CITY POINT ROAD
87-S-7 PEAKS ISLAND

Original S. Trutt - City Point Rd - P.D.
 Addition to front porch

Amendment No. 1

AMENDMENT TO APPLICATION FOR PERMIT

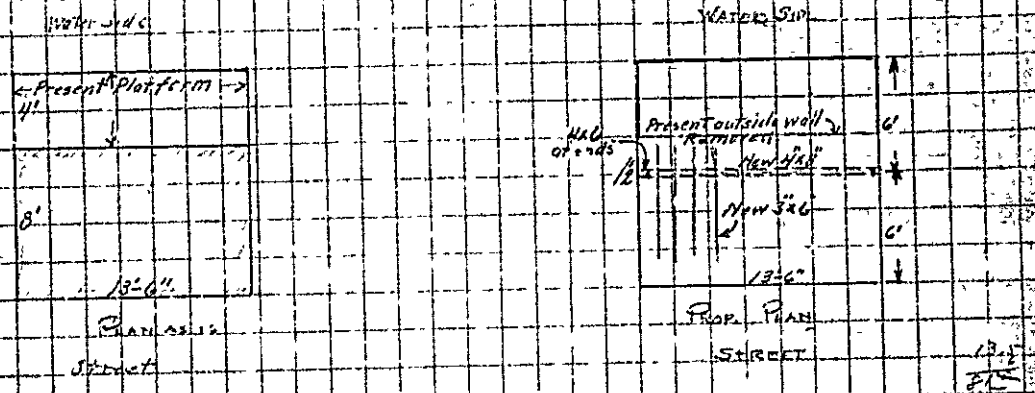
No more as I can get it, the following is to be done

Prop 3x6 wood span gird for 1631# O.K.

11/8 girds on 13' span grid for 1917#
 $2 \times 18.5 \times 45 = 3645$ # needs center post or 8x8 (dim is 11'2")
 on 8' HP

Supports under present platform, new outside wall should be known as there will be an additional load of at 2600# come on present sill. If present wall sill had the 10' vertical it is O.K. but would not work out with 6' vertical sills of 8' HP

Present floor load $2 \times 13 \times 45 = 1170$
 Roof + outside wall 2530
 3705 # possible sill load

$\frac{462.5}{3.75} \times 1.25 = 72150 = 6.5$ # out Req.
 1100

Removal of outside wall not stated as amendment.
 No side yard clearance shown.
